**Re: Objection – Calloway Project (63148), Willamette National Forest,
McKenzie River Ranger District**

Project Description: The Calloway project area encompasses 45,041 acres and is located on the McKenzie River and Sweet Home Districts of the Willamette National Forest north of Blue River, Oregon. Proposed actions include commercial thinning, fuels reduction, meadow restoration, culvert work, and road construction and maintenance. This project proposal involves:

Cascadia Wildlands and Oregon Wild (“Objectors”) respectfully submit these objections, pursuant to 36 C.F.R. § 218, to the Calloway Project final Environmental Assessment (EA) and draft Decision Notice/Finding of No Significant Impact (DN/FONSI), issued August 12, 2025, by the Willamette National Forest.

Unit 51:

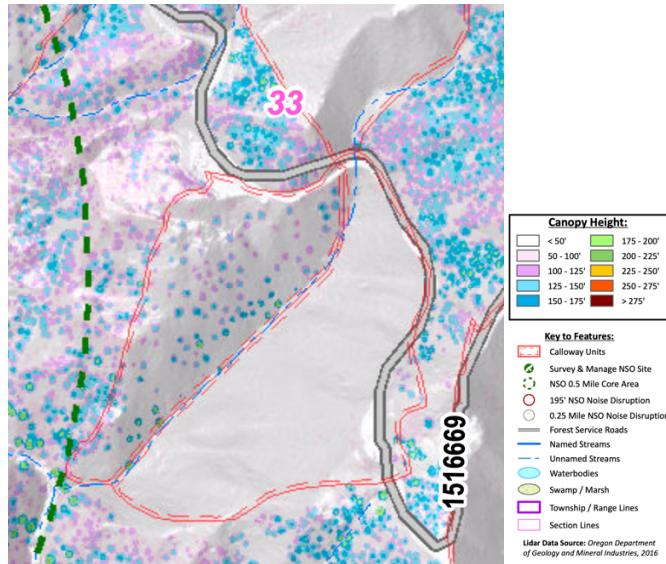
There are a number of visibly large and mature trees looking down into the stream valley below. The ridge's slope is very steep; easily 45 degrees and very difficult to traverse. Lidar data shows consistent scattering of multiple tall, large trees.

Recommendation: The USFS should remove this unit from the project as it does not align with the proposed action listed under purpose and need of project within project's scoping letter (signed December 9th, 2022) to "Treat up to 8,213 acres of timber less than 80 years old in previously managed stands."

Unit 218:

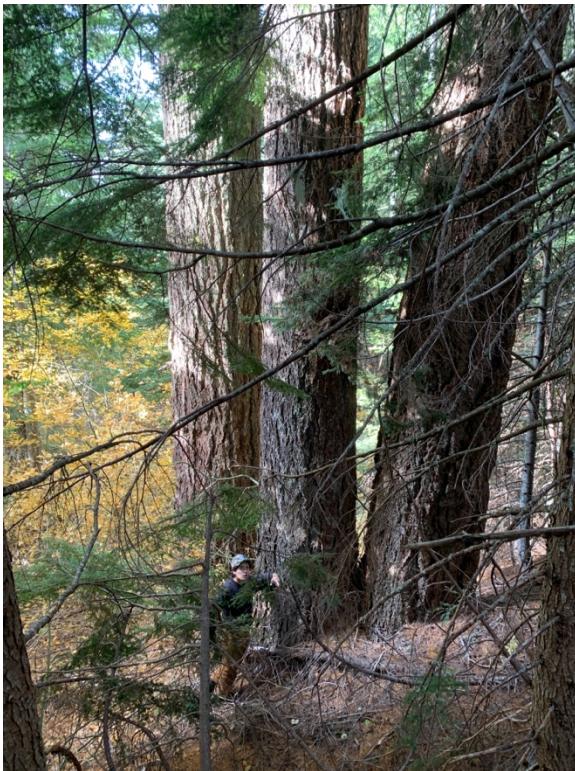
This stand is along a very steep slope and contains large old growth trees including a 35 inch DBH hemlock, 37 inch DBH western red cedar, and 55 inch DBH Douglas fir. There are multiple large trees and snags with ample wildlife evidence and appears to be excellent habitat for the northern spotted owl.

Recommendation: The USFS should remove this unit from the project as it does not align with the proposed action listed under purpose and need of project within project's scoping letter (signed December 9th, 2022) to "Treat up to 8,213 acres of timber less than 80 years old in previously managed stands."
